AMENDMENT NO. 1 MAY 2023
TO
IS 17483 (PART 2) : 2020 GEOSYNTHETICS — GEOCELLS — SPECIFICATION
PART 2 SLOPE EROSION PROTECTION APPLICATION

FIG. 2 (a) INDIVIDUAL EXPANDED CELL

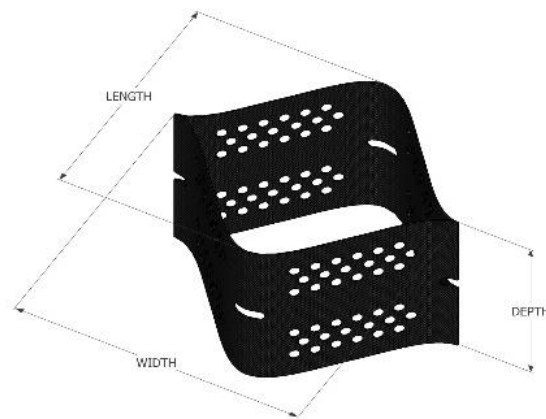
(*Page 1, Fig. 2*) — Substitute the following figures for existing:

‘NOTE — The profile of geocells are generally curvilinear rhomboidal structures [*see* Fig. 1 and Fig. 2 (a)].’

FIG. 5 (a) ULTRASONIC SEAM WELD

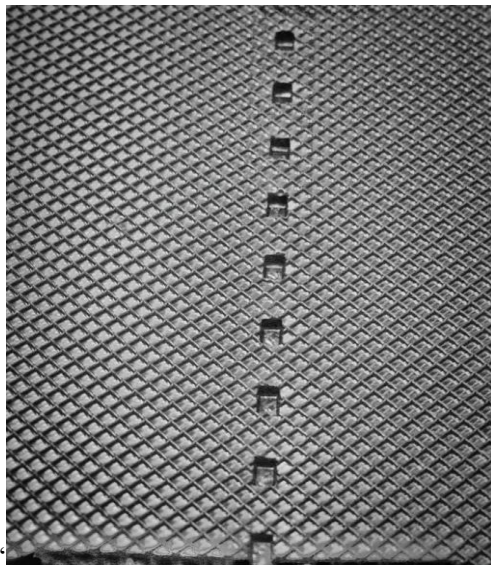
(Page 2, Fig. 5) — Substitute following figures for existing:

The adjoining strips that form the geocell panel shall be welded ultrasonically. The seam weld thus formed shall be uniform [*see* Fig. 5 (a)]. For uniform seam strength, ultrasonic weld melt pool width shall be 10 mm maximum [*see* Fig. 5 (b)].
